## REVISED RESPONSE TO REQUEST FOR ADDITIONAL INFORMATION

### APR1400 Design Certification

Docket No. 52-046

RAI No.: 252-8299  
SRP Section: 03.07.02 – Seismic System Analysis  
Application Section: 3.7.2  
Date of RAI Issue: 10/19/2015

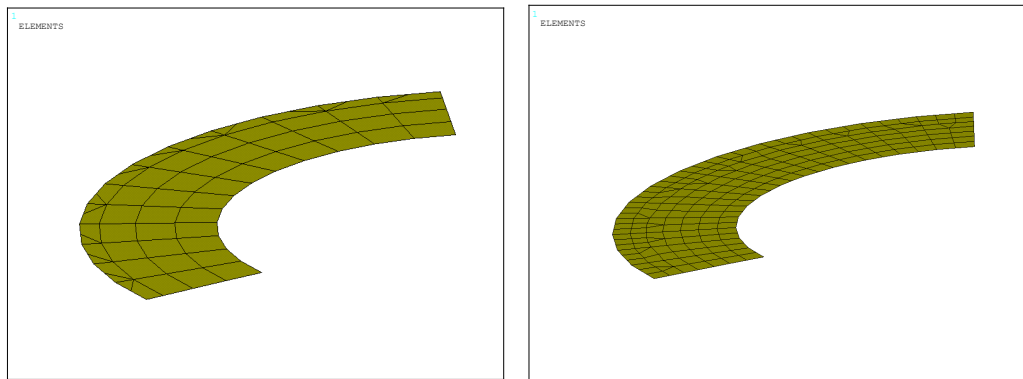
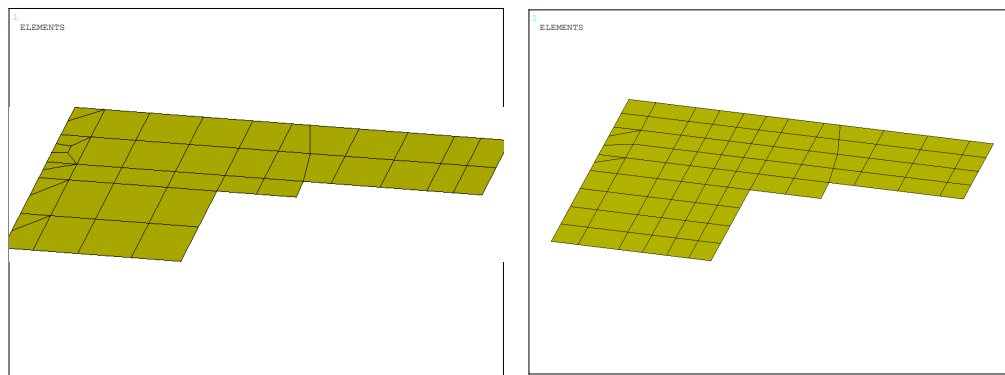
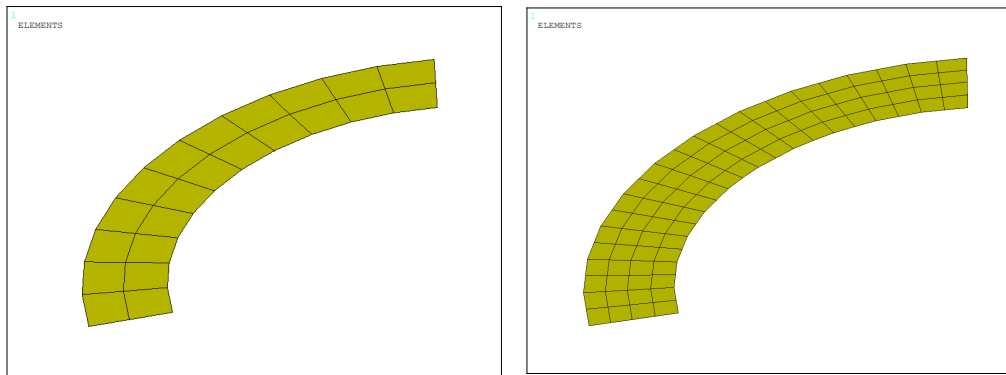
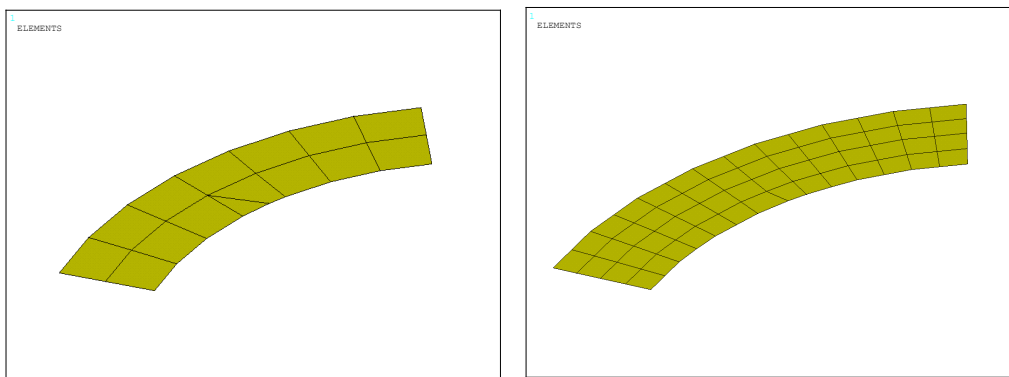
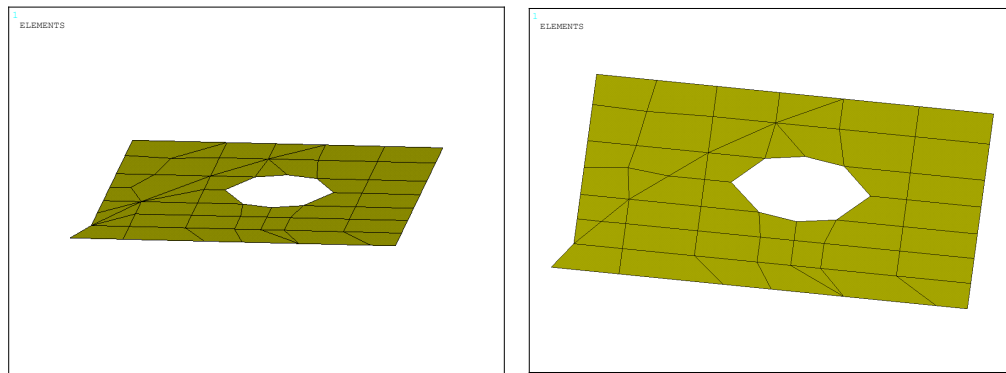
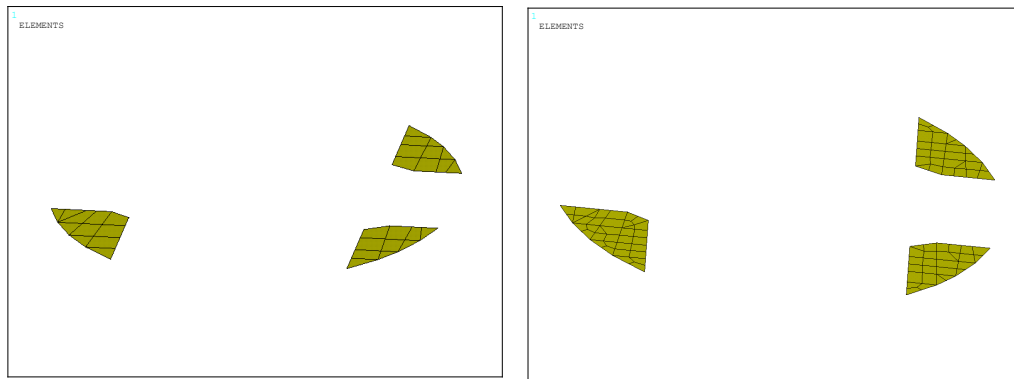
SRP Section 3.7.2.II.3D provides the acceptance criteria regarding the representation of floor loads, live loads, and major equipment in a dynamic model. In addressing these SRP criteria, DCD Section 3.7.2.3.3 includes a description of masses that are assumed to contribute to the inertial forces in the seismic analyses. However, this DCD section did not specify the magnitude of such masses. For example, based on the description in DCD Section 3.7.2.3.3, it could be inferred that 100% of the live load is used in the seismic load case. The staff review finds that Section 3.2.5 and Table 4-7 in APR1400-E-S-NR-14002-P,

for the RCB and AB, respectively, provide additional information on the magnitude of the masses described in DCD Section 3.7.2.3.3. Section 3.2.5 in APR1400-E-S-NR-14002-P states that 25 % of floor live load or 75% of snow load are applied on the roof of the containment which appears to conflict with DCD Section 3.7.2.3.3. Based on these two statements it is not clear to the staff what floor live load has been considered on all floors of the reactor containment building. Therefore the staff request the applicant to clarify in the DCD how the SRP Section criteria regarding floor loads is addressed in the models used for seismic analysis.

In the seismic analysis model of the RCB, the slabs at EL. 114'-0", 136'-6", and 156'-0" between the secondary shield wall (SSW) and the containment shell (CS) are not modeled in accordance with the decoupling criteria presented in the USNRC SRP 3.7.2. All the masses of those slabs considering the self-weight, 50 psf of the miscellaneous attachment dead load, and the major equipment loads are lumped onto the SSW. The slabs between the SSW and the CS are completely connected to the SSW, and there are a minimum of 2 inches gaps between CS and the slabs. In addition, the supporting beams under the slabs have sliding connection at the CS. Therefore, all the horizontal slab masses would be actually lumped onto the SSW, and part of the vertical slab masses would be actually applied to the CS due to the beam seats at the CS. However, concentration of the vertical slab masses onto the SSW only would not cause much frequency discrepancies because the slab masses are not large in comparison with the SSW and the CS masses. Therefore, the SSW is considered as the main supporting structure for the slabs between the SSW and the CS in the seismic analysis model of the RCB.

Except for the slabs between the SSW and the CS described above, all other slabs in the RCB are modeled in the seismic analysis model of the RCB. The figures and the fundamental frequencies of those slabs in the coarse mesh and fine mesh RCB models are presented in Figures 1 through 6 and Table 1. The average mesh sizes of the coarse and fine slab models are approximately 5 ft x 5 ft and 10 ft x 10 ft, respectively. As shown in Table 1, the fundamental frequencies of the fine mesh slab models are higher than 50 Hz. The fundamental frequencies of the coarse mesh slab models are similar to the fine mesh slab models. These results indicate that most of the slabs that are modeled in the seismic analysis model of the RCB are quite rigid, and the mesh size of slabs in coarse mesh model is sufficient to accurately capture the out-of-plane flexibility of the slabs.

Table 1. Fundamental Frequencies of Slabs in Coarse and Fine Mesh RCB Models

Elevation	Fundamental Frequencies (Hz)		Fundamental Frequency Ratio (Coarse / Fine)
	Coarse	Fine	
100'-0"	48.73	50.20	0.97
111'-0"	225.08	229.71	0.98
114'-0"	87.17	93.09	0.94
125'-0"	88.18	94.08	0.94
133'-3"	322.59	323.56	1.00
156'-0"	265.83	275.84	0.96
